CLEARFIELD CITY PLANNING COMMISSION MEETING AGENDA

STAFF REPORT

SUBJECT: Discussion and Possible Action on **SP 2023-0201**, a site plan approval request by Jarod Hall with Divelept Design for a three-story mixed use building at the subject property. **Location:** 246 East 200 South (TIN: 12-003-0042). **Parcel Area:** 0.33 Acres. **Zone:** U-C (Urban Core Commerce). **(Administrative Action).**

Project Information	
Project Name	246 UHB Mixed-Use
Site Location	246 East 200 South
Tax ID Number	12-003-0042
Applicant	Jarod Hall, Divelept Design
Owner	True Real Estate Holdings, LLC
Proposed Actions	Site Plan Review Approval
Current Zoning	U-C (Urban Core Commerce)
Site Area	0.33 Acres

25 WEST ELEVATION REVIEW
1/8" = 1'-0"

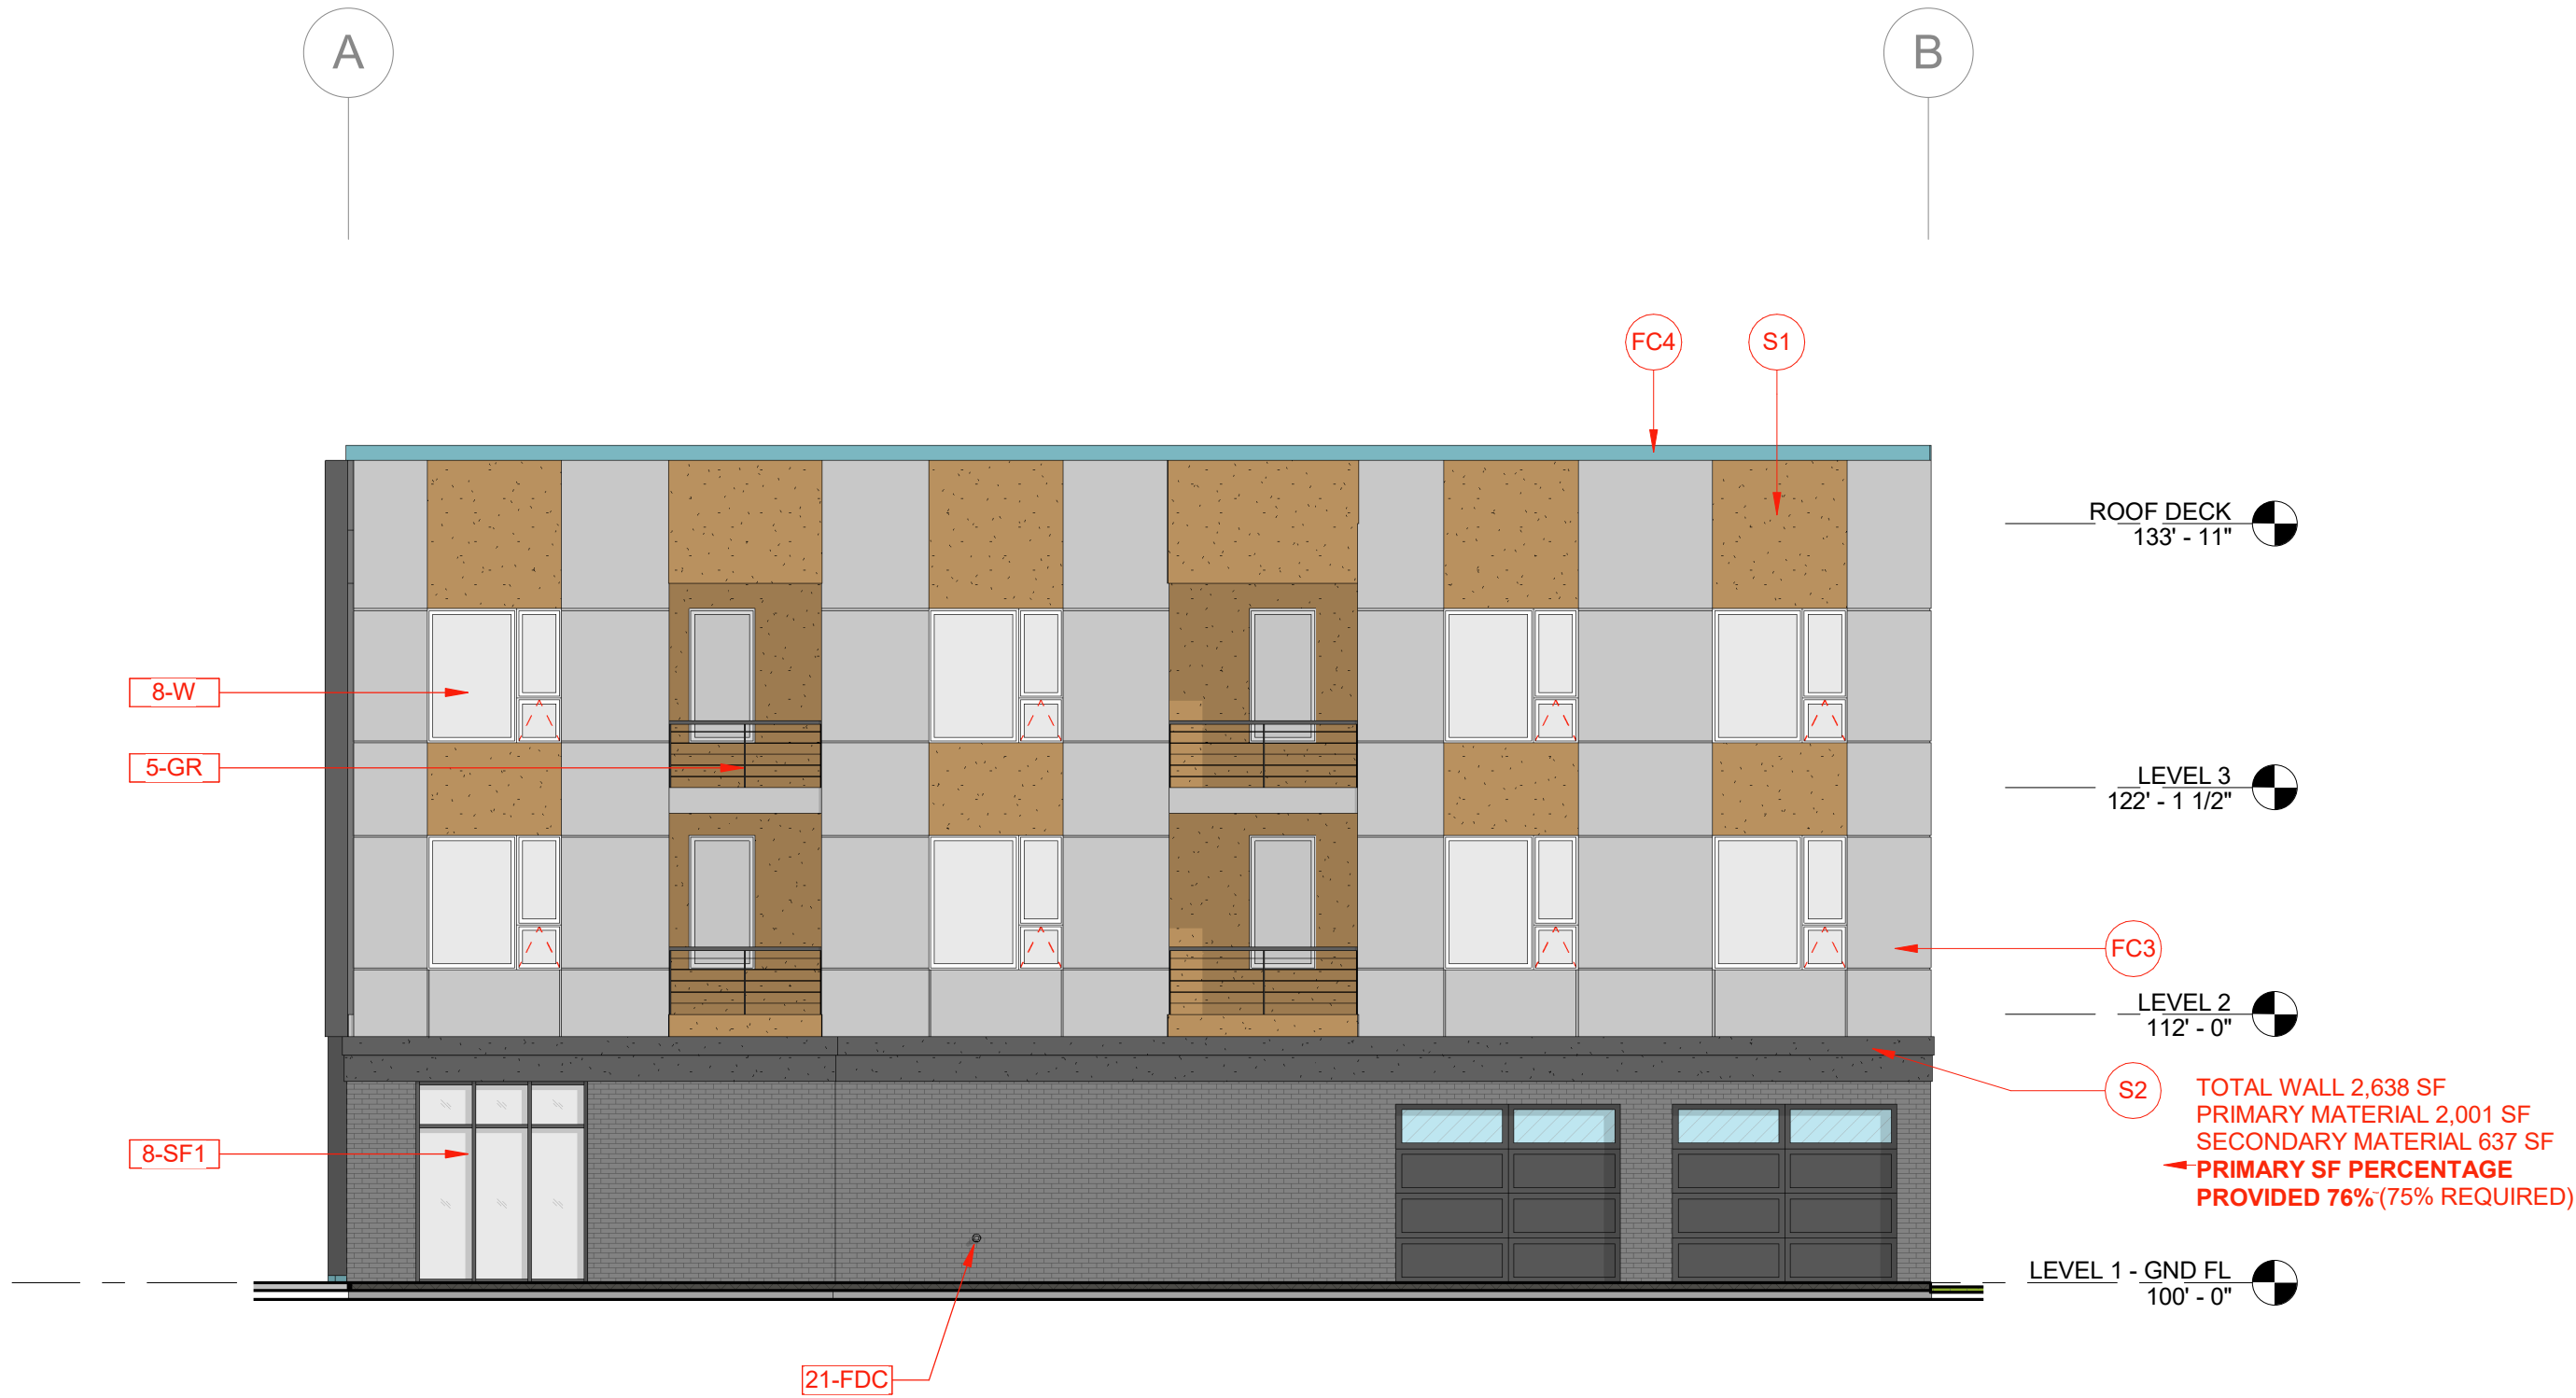
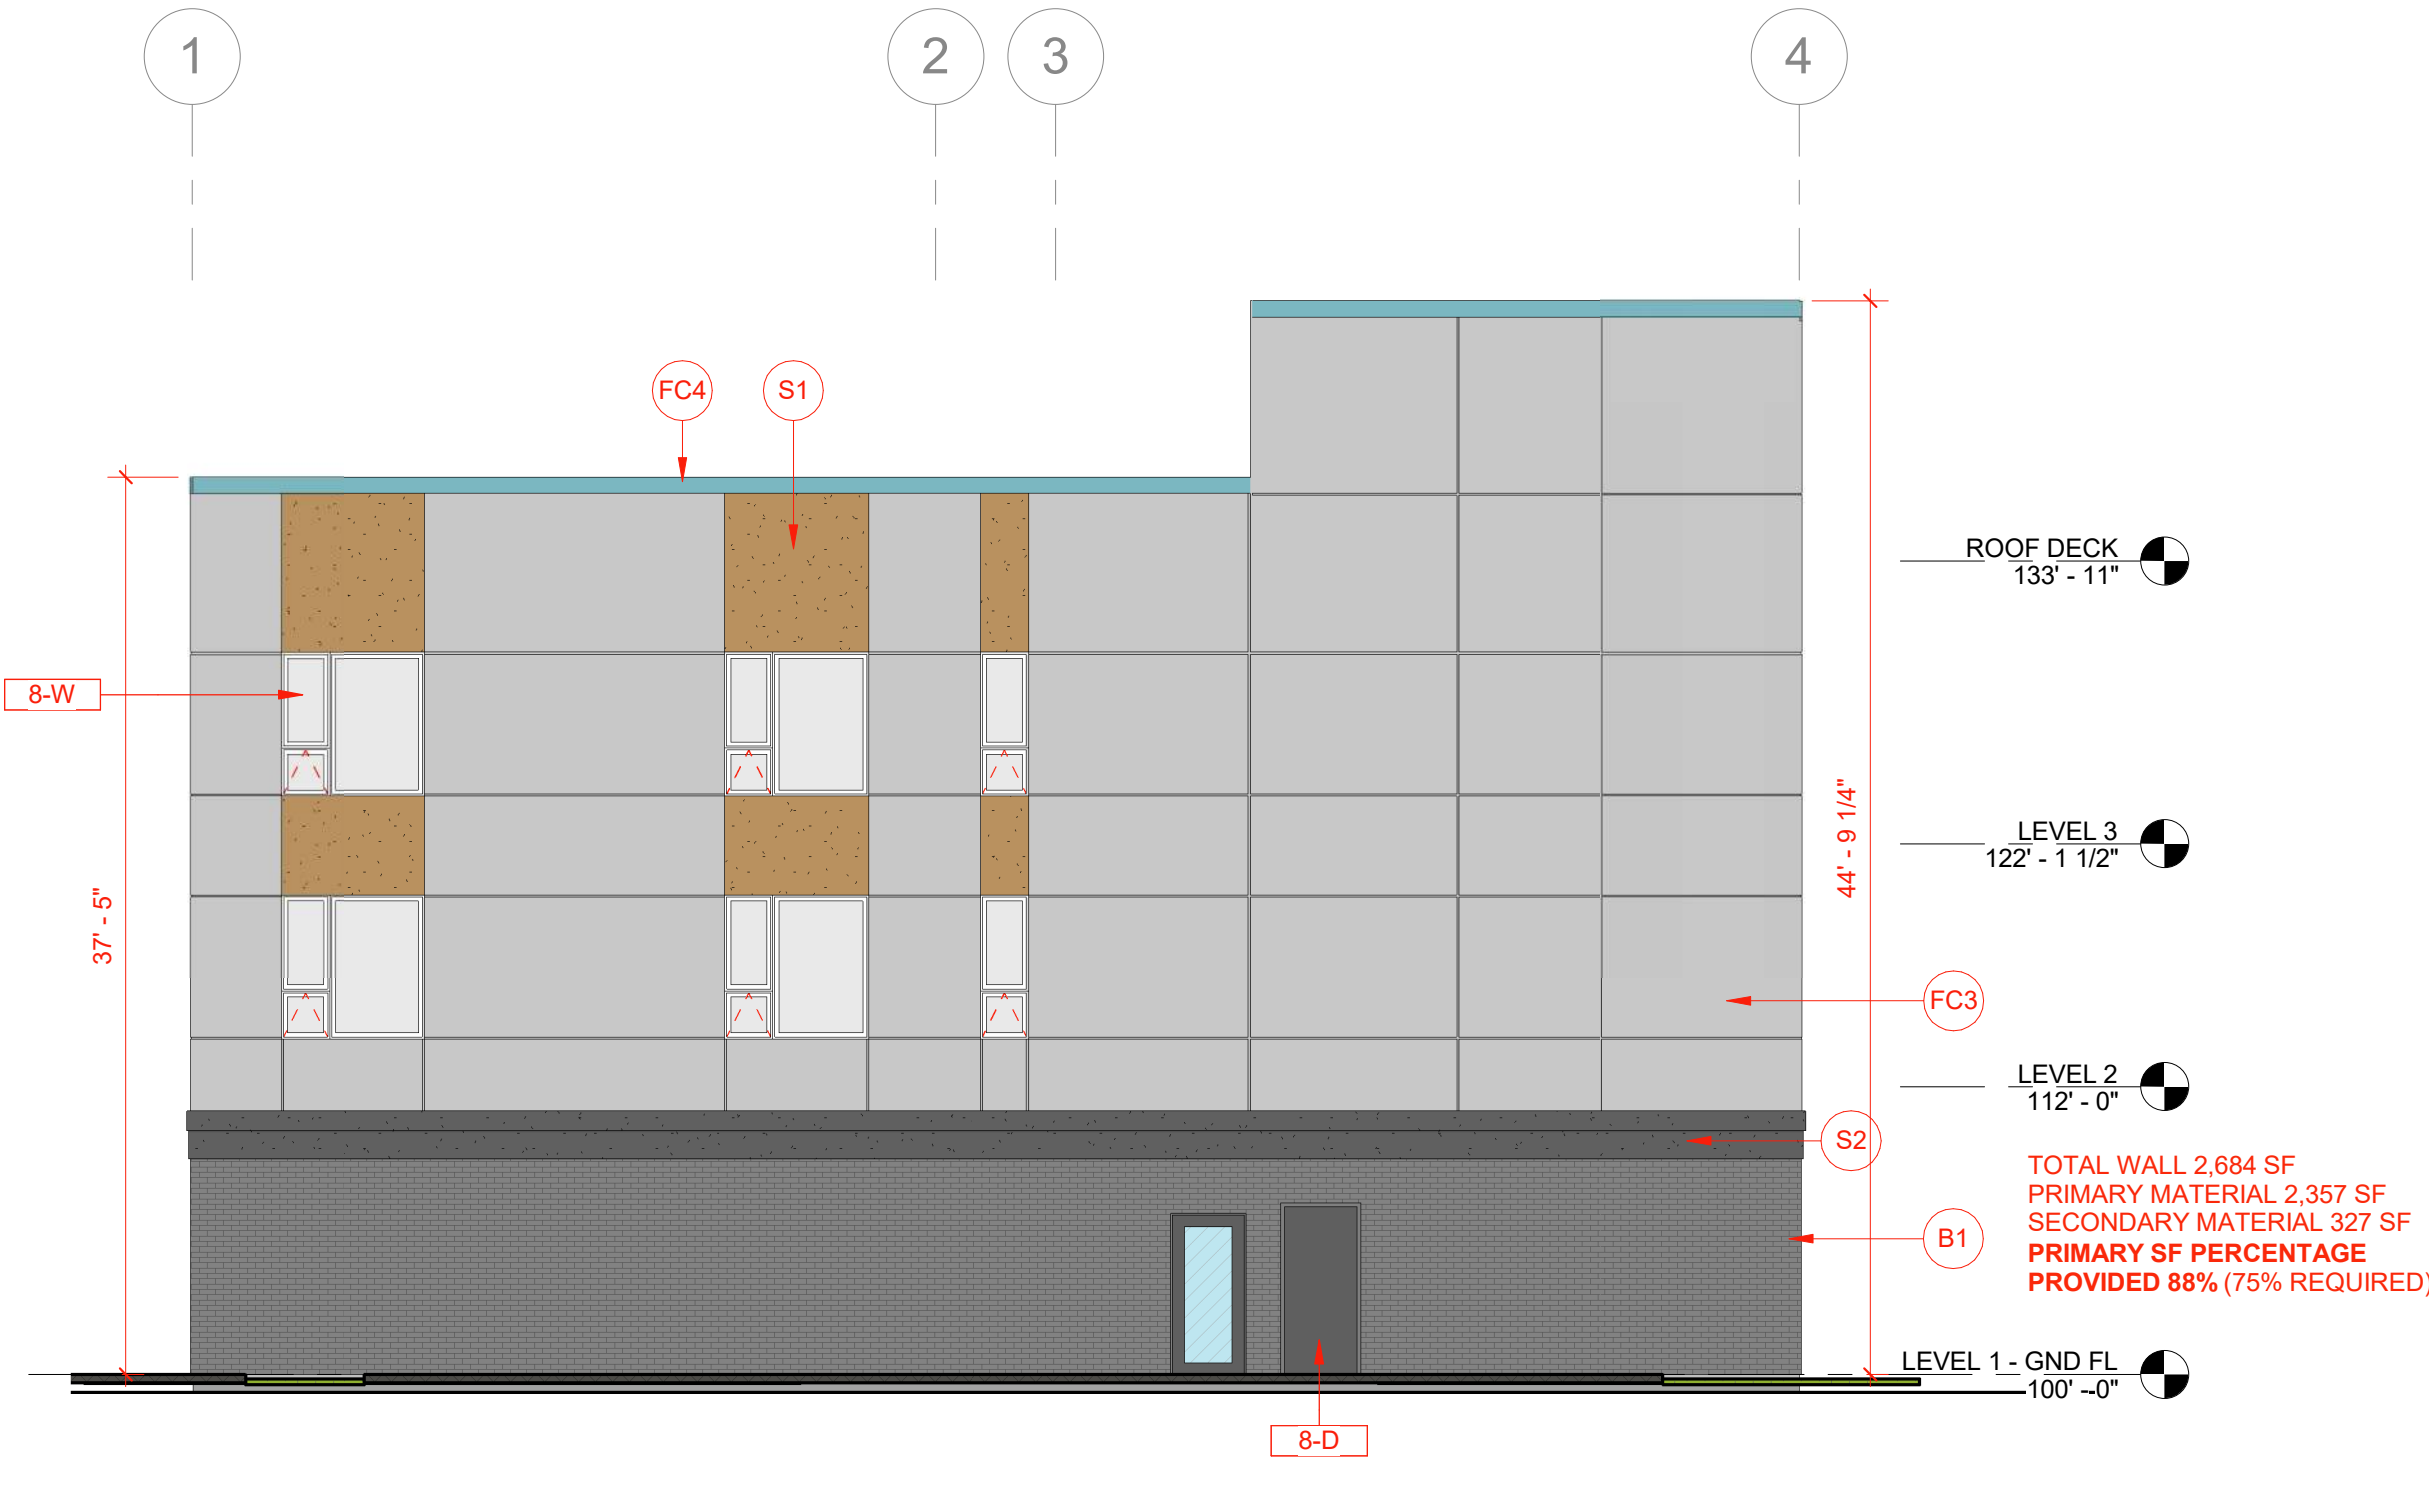
<i>Horizontal Façade Divisions:</i> Required within 3' of the ground story and at the top of the highest story.	Non-Compliance with FBC <u>Staff Note:</u> The change in materials from the ground floor to the upper floors complies with this standard. There is no façade division at the top of the highest story. This can be accomplished with a cornice, belt course, molding, string course, or other continuous horizontal ornamentation a minimum of one and a half inches in depth.
---	--

Standard:	Staff Analysis:
<i>Permitted Roof Type:</i> Parapet or Flat	Non-Compliance with FBC <u>Staff Note:</u> The project provides a parapet roof type with an indistinct height. It appears to be a 3.5' parapet in some areas, but more detail is needed to show that the parapet height around the entire perimeter is within the allowed two to six feet and high enough to screen the roof and any roof appurtenances from view. Additionally, an expression line shall define the parapet from the upper stories of the building on all sides and shall also define the cap (FBC 6.12 Roof Types).

- 4) The plans shall be revised to include a horizontal façade division for the top of the highest story of the street facing façade that meets the façade articulation standards found in Chapter 6 of the Clearfield City Downtown Form Based Code. This can be accomplished with the horizontal expression line referenced in Condition #4.

- 5) The plans shall be revised to include a horizontal expression line to define the parapet from the upper stories of the building on all sides.
- 6) The plans shall be revised to include a note indicating that commercial quality doors, windows, and hardware will be used for the building.
